ADDENDUM #1

Job #: 241459 **Project Title** Midway District Streetscape Ph. 2
Client: City of Fort Thomas

Issue Date: March 11, 2025
Bid Date: March 14, 2025

PROJECT NO.	
241459	
DISCIPLINE	
CIVIL	
SHEET NAME	
C5.1	
SHEET	OF
17	44

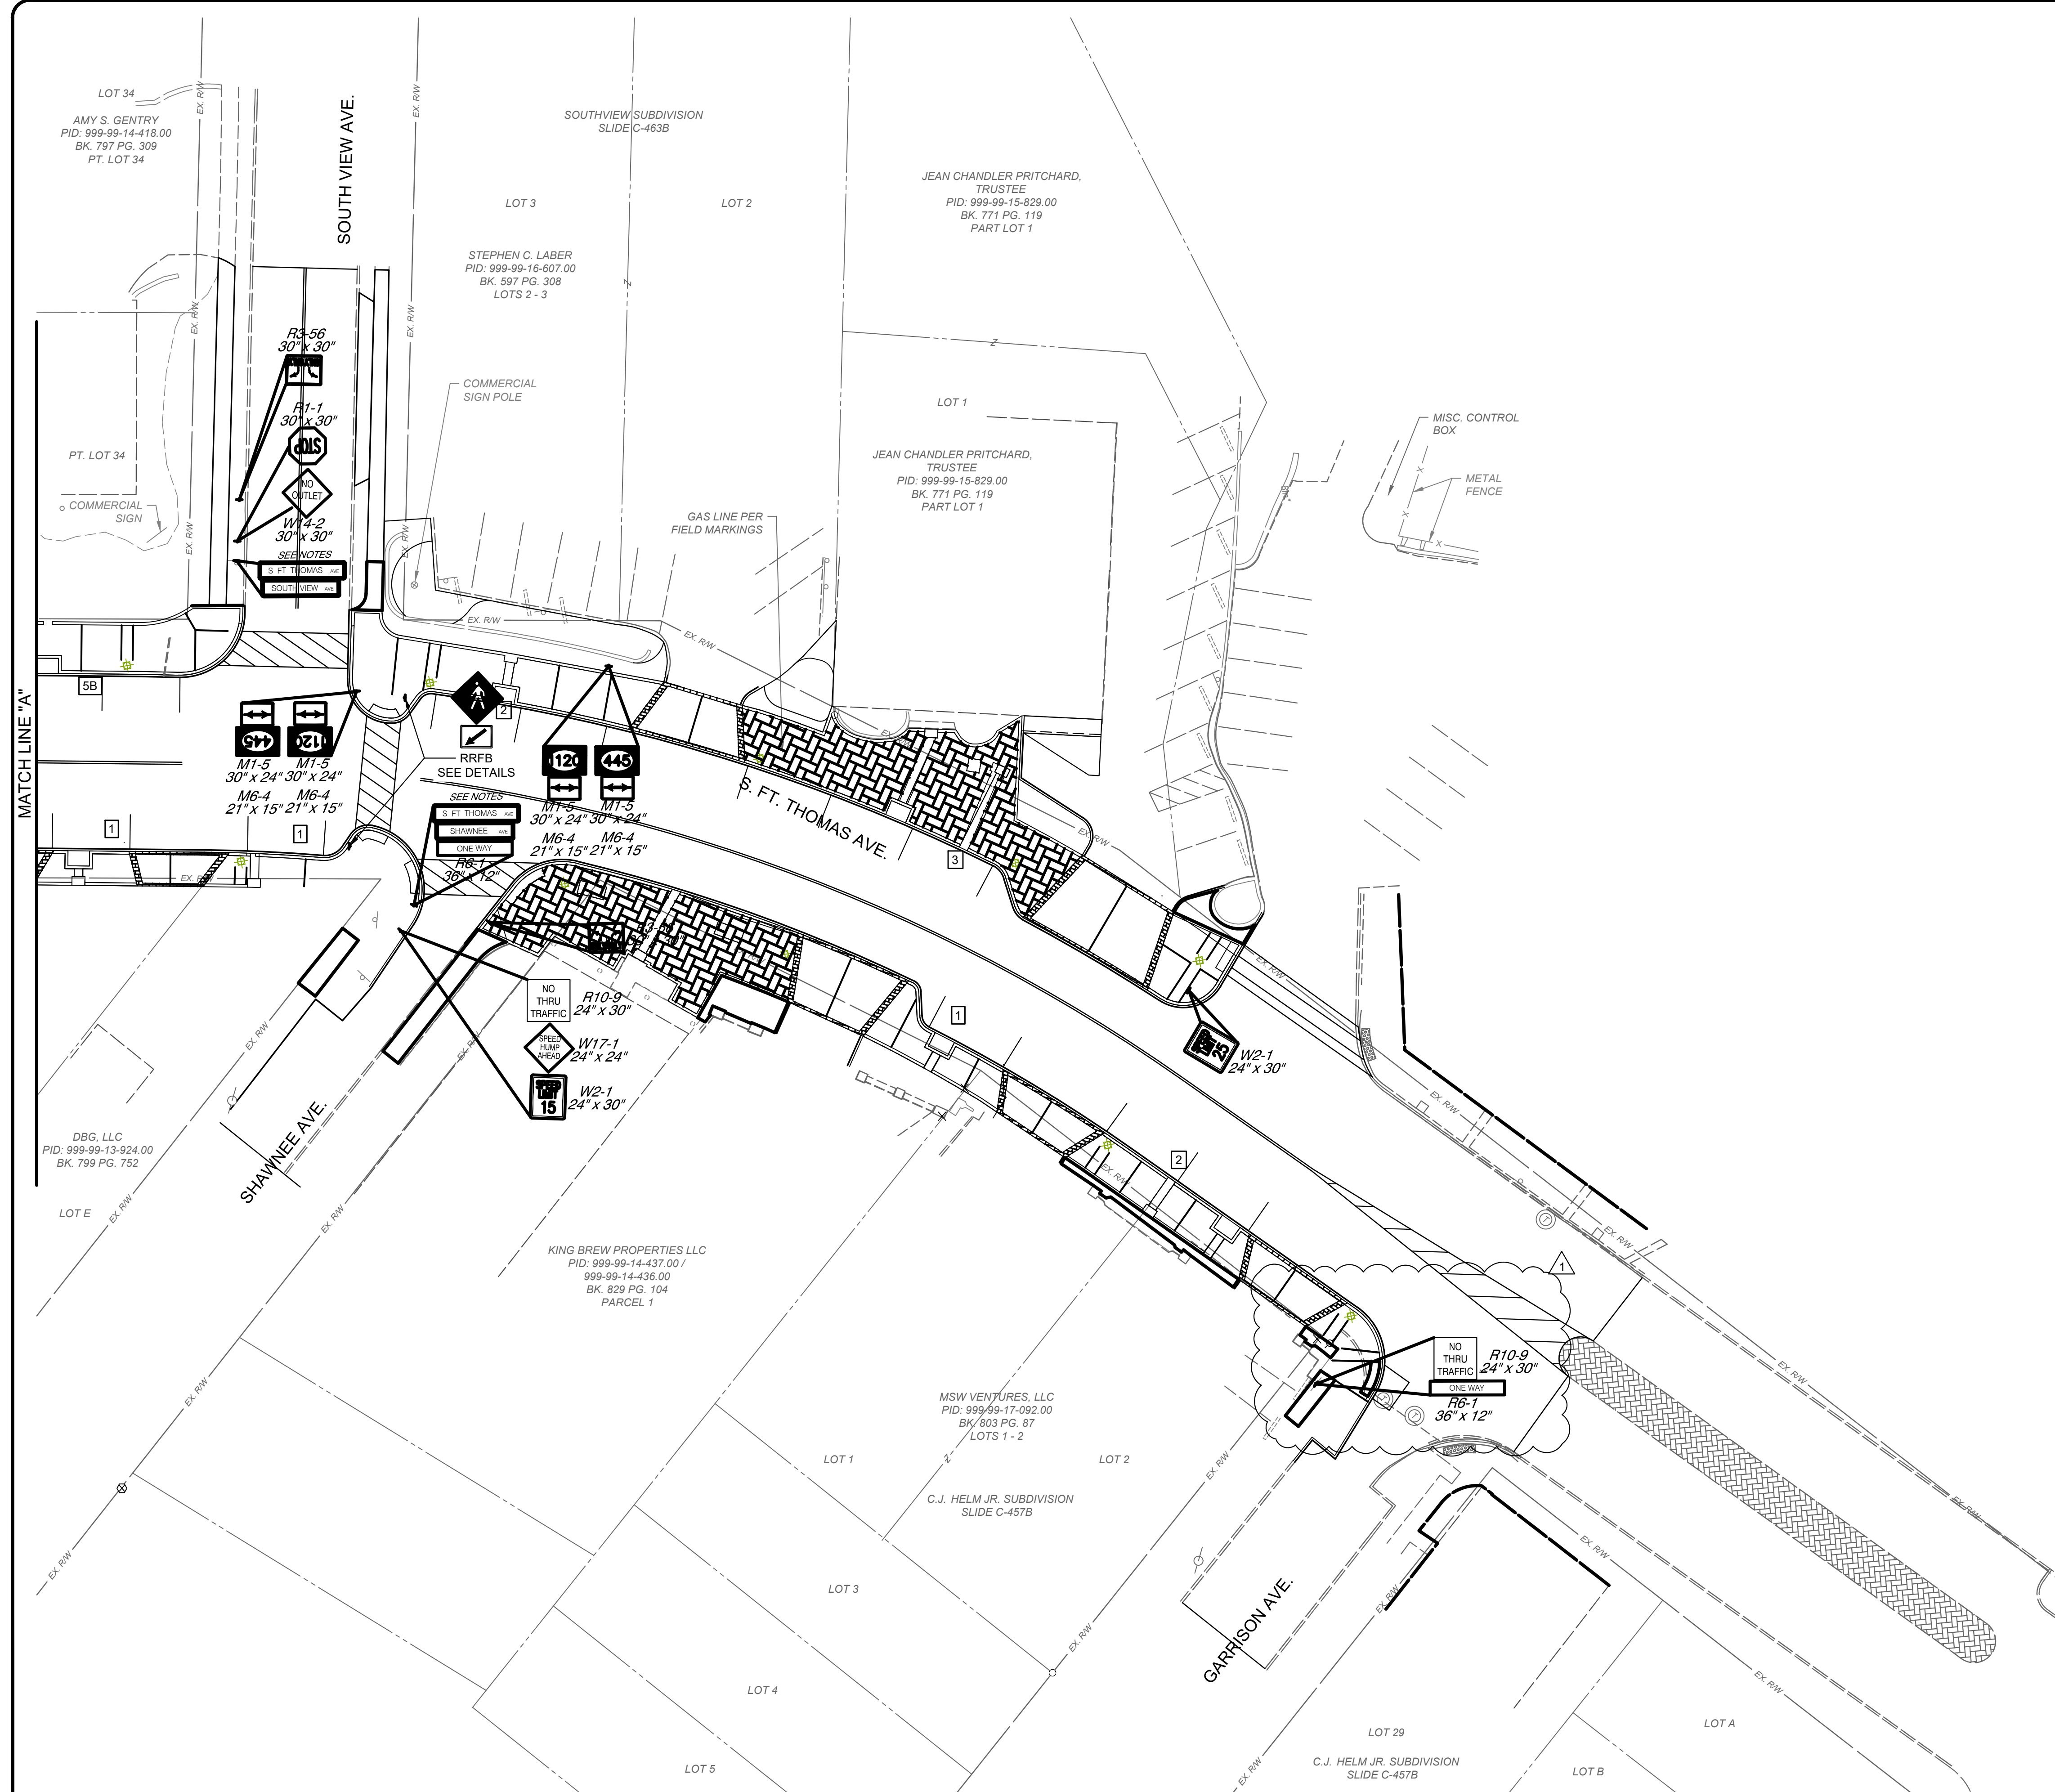
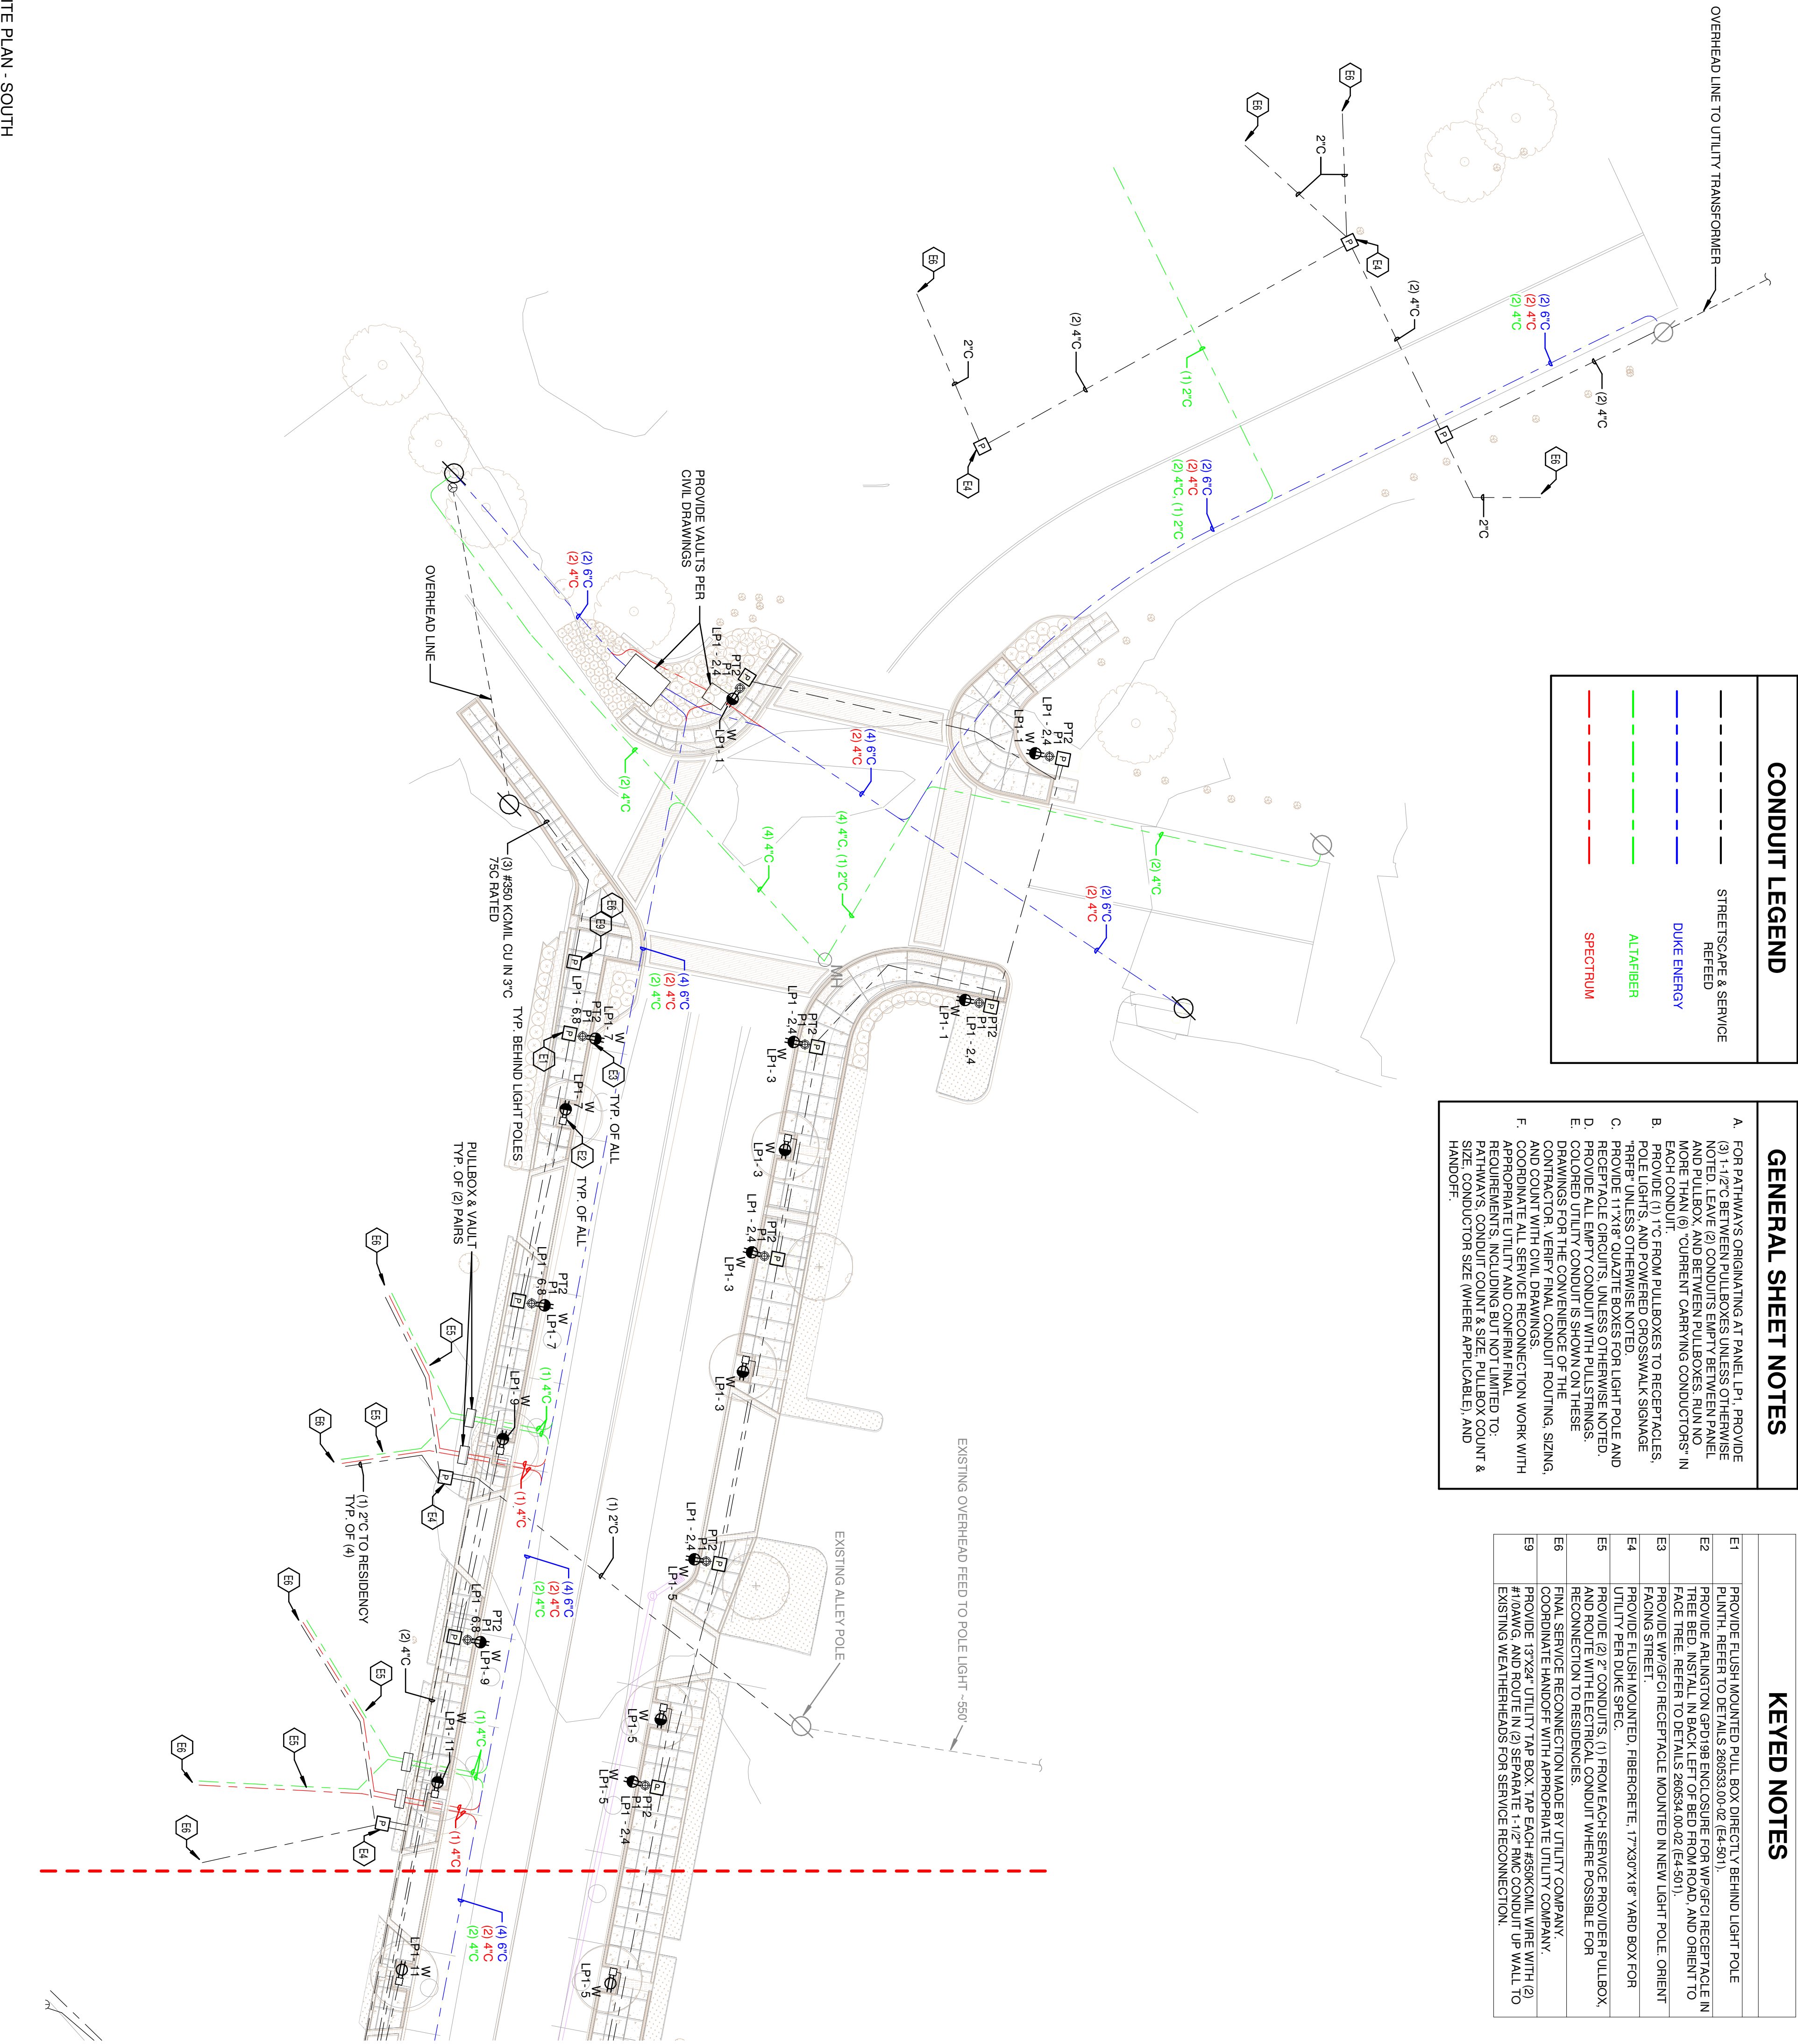
- Signage was added at the corner of Garrison Ave.
- Additional utility service conduits for reconnects were added. The quantities on the bid tab have been revised.

SHEET
EO-101

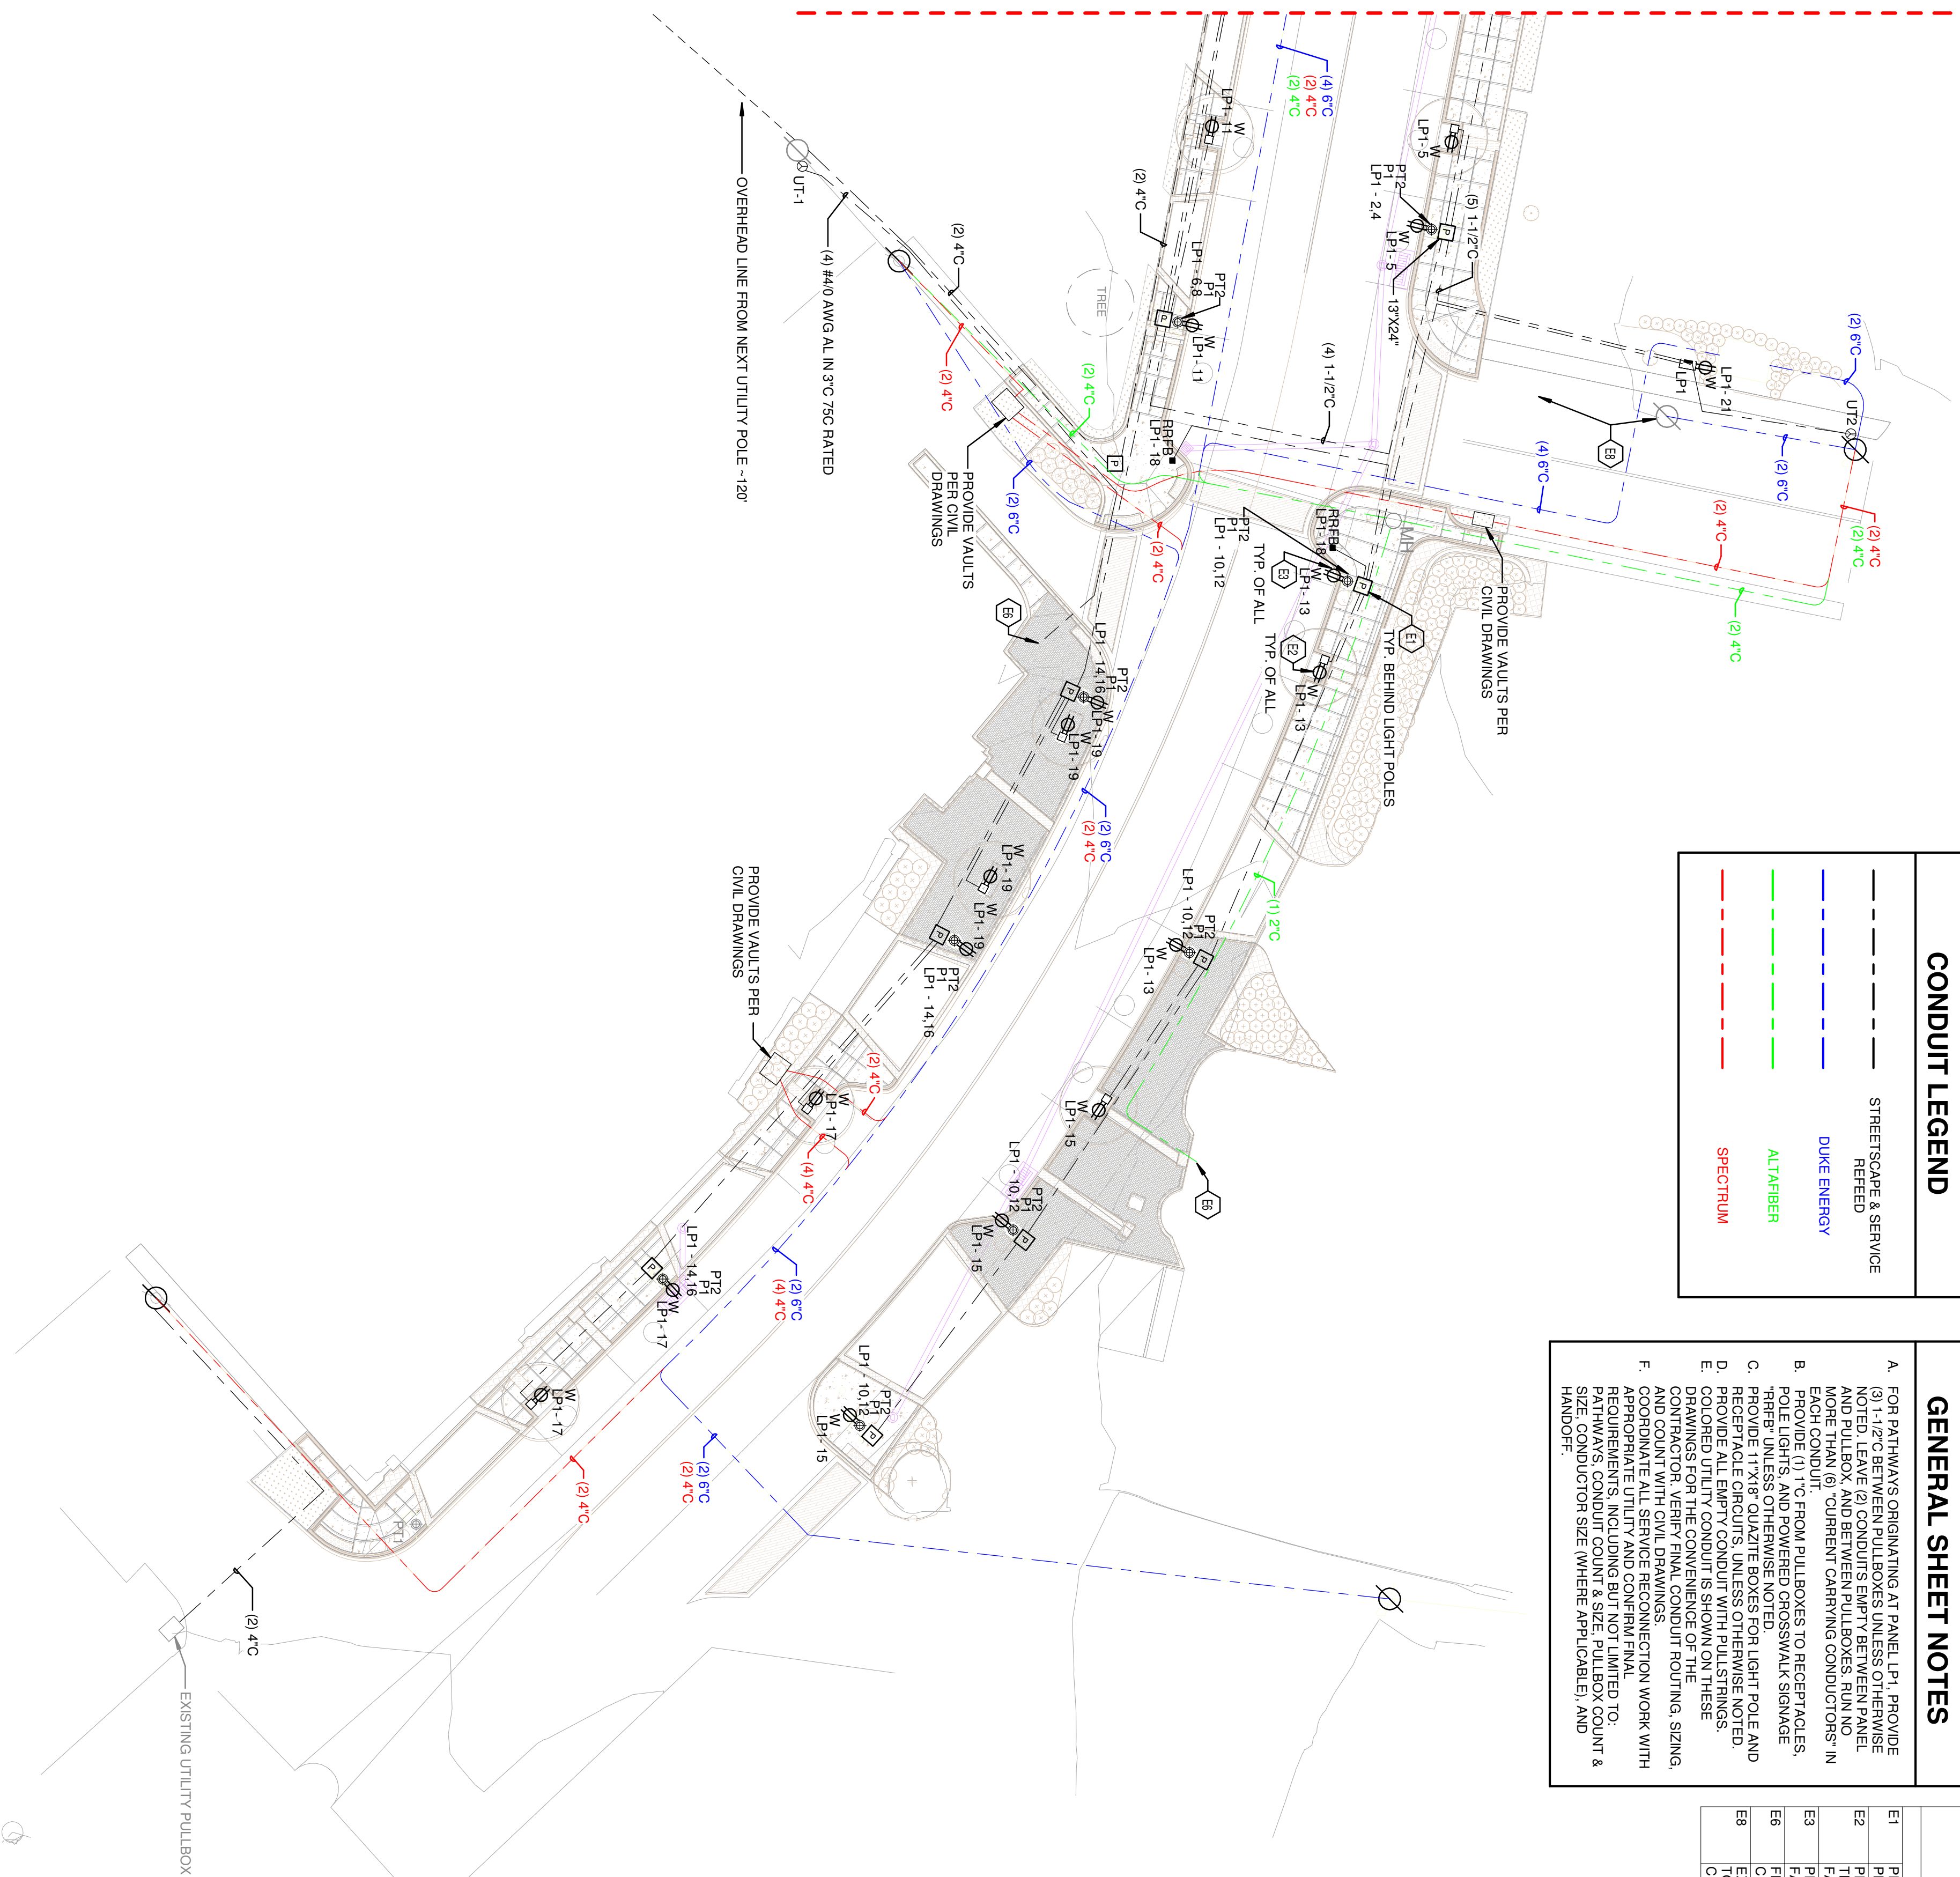
- The notes on the electrical plans indicated that the “vaults” for the utility relocation were by “others”. The note has been revised to refer to the civil sheets. The vaults/pullboxes are included in the “Utility Relocate” portion of the bid.
- The plinth is 32”x32” while the light pole foundation is 24”. This is correct, the square plinth will overhang the circular foundation. The site contractor will pour concrete as part of the sidewalk up to the foundation. The concrete from the sidewalk and foundation will support the plinth.
- A request was made to remove the trenching and backfill from the conduit item and make a separate line item. The bid tab has been revised.

Revised per Addendum 1
